CITY OF YONKERS

RE: IFB-6726: Phase 1 of Roof Doors Boiler System Replacement and Site upgrades at School 29

ADDENDUM No. 3: Informational – Response to RFI's

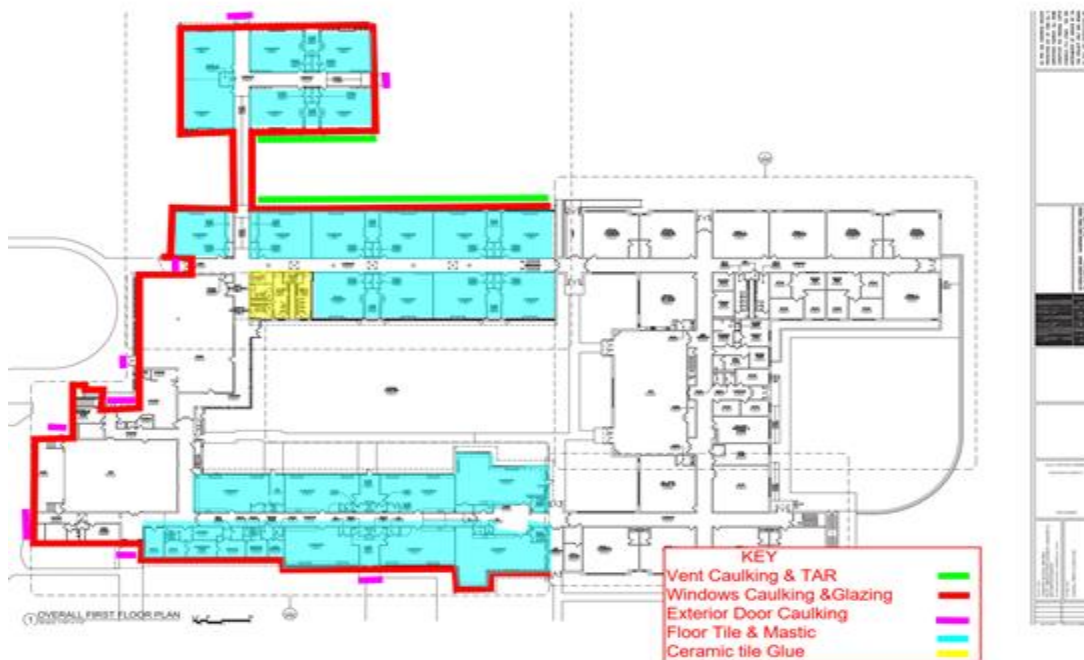
8. Does all the exterior doors that are listed on the door schedule Plan A-700, gets caulked abated. Plans attached to the asbestos report show otherwise. See below. Please clarify.

Response: Yes all exterior doors as shown on PS29 ASB-100.
